# **SERVICE LETTER 191**

## FIRE BOSS WATER SCOOP SWITCH REPLACEMENT

Aircraft Makes/Model(s):	Float Model(s):	Compliance: As required	By: MAB	
AT-802 & AT-802A 10000 Amphibious		Part Number: 1009904	Approved: SDW	
		Date: 5/9/2019	Revision: A

DETAIL A

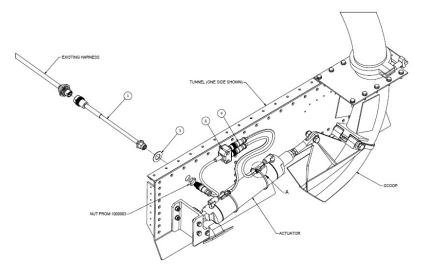
The originally installed water scoop switch assemblies may have issues with water contamination of the various connectors. The new method utilizes parts with molded connectors more suitable for prolonged water exposure.

Remove existing water scoop switches and replace with new style switch assemblies as per this Service Letter.

4. If not already done, mark the Splitter 2 Branch 4 Wire (U0163-11) with "DN" at the #1 position, and "UP" at the #2 position. The "UP" Switch will be towards the aft end of the float and the "DN" switch will be towards the fwd end of float.

- 5. Open up the diameter of the Washer (NAS1149D0963J) to 19/32, to fit Adapter receptacle.
- 6. Remove Rubber O-Ring from rear mount receptacle of Harness Adapter. Replace with modified Washer.
- 7. Ensure connector end and internal area remain free of sealant.
- 8. Insert Rear Mount Receptacle of Harness Adapter (1009903) through tunnel access hole from outside. Secure with nut and taper facing inwards (helps to center connector in larger hole). Connect trunk end of Splitter to Adapter Harness.
- Remove screws from Inductive Magnet Sensors (S4685792). Mount switches on scoop hydraulic actuator using ASB-6 Straps (M6965106) and Cord Sets (S693351). See Detail A.
- 10. Re-install hydraulic actuator assembly with previously removed hardware>
- Secure Splitter Harness and Switch assemblies with Plastic Cable Tie (PLT-25-M).
